53-1002757-07
27 February 2015

FastIron Family

Documentation Updates

Supporting IronWare R07.4.00 releases

FIGURE 1 2-post rack mount kit for Brocade ICX 6610

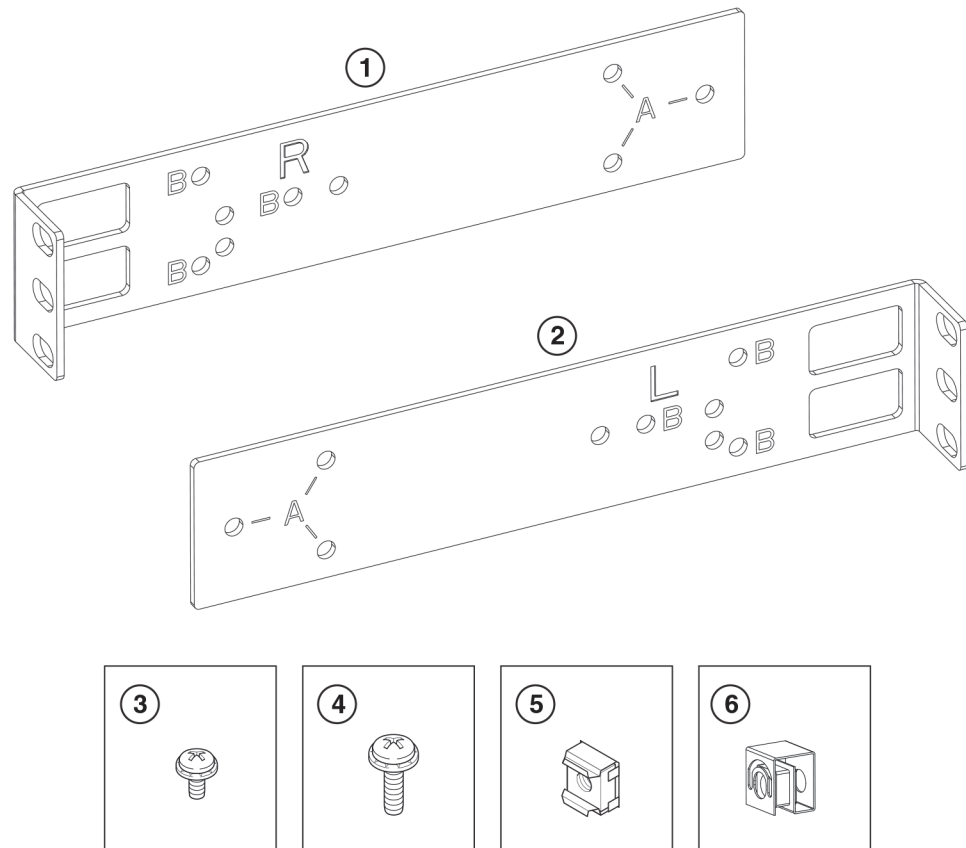
The package contents shipped with an ICX 6610 switch includes two 1M Passive copper QSFP stacking cables.

Remove the rack mount kit from the shipping carton. The kit contains the following:

- Two L-shaped mounting brackets.
- Sixteen 8-32 x 3/8 in., panhead Phillips screws with patchlocks.
- Four 10-32 x 5/8 in., panhead Phillips screws (torque to 25 in-lb, 29 cm-kg)
- Eight 32-10 retainer nuts (for square-hole rack rails)
- Eight 32-10 retainer nuts (for round-hole rack rails)

FIGURE 6 4-post rail kit

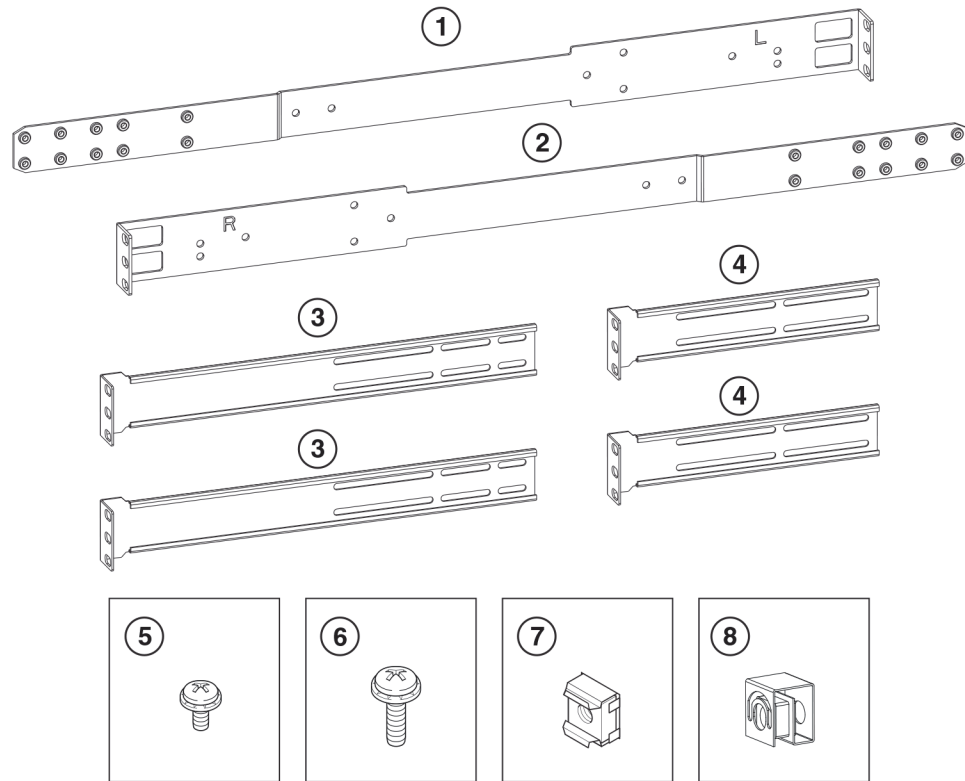
Kits for 4-post rack mounting are not included in the shipping carton and must be ordered separately.

Remove the rack mount kit from the shipping carton. The kit contains the following (Figure 6):

- Two mounting brackets.
- Two pairs of extension brackets. Use the shorter pair for rack that are up to 27 inches deep. Use the longer pair for racks up to 32 inches deep.
- Thirty-two 8-32 x 3/8 in., panhead Phillips screws with patchlocks.
- Eight 10-32 x 5/8 in., panhead Phillips screws (torque to 25 in-lb, 29 cm-kg).
- Eight 32-10 retainer nuts (for square-hole rack rails).
- Eight 32-10 retainer nuts (for round-hole rack rails)
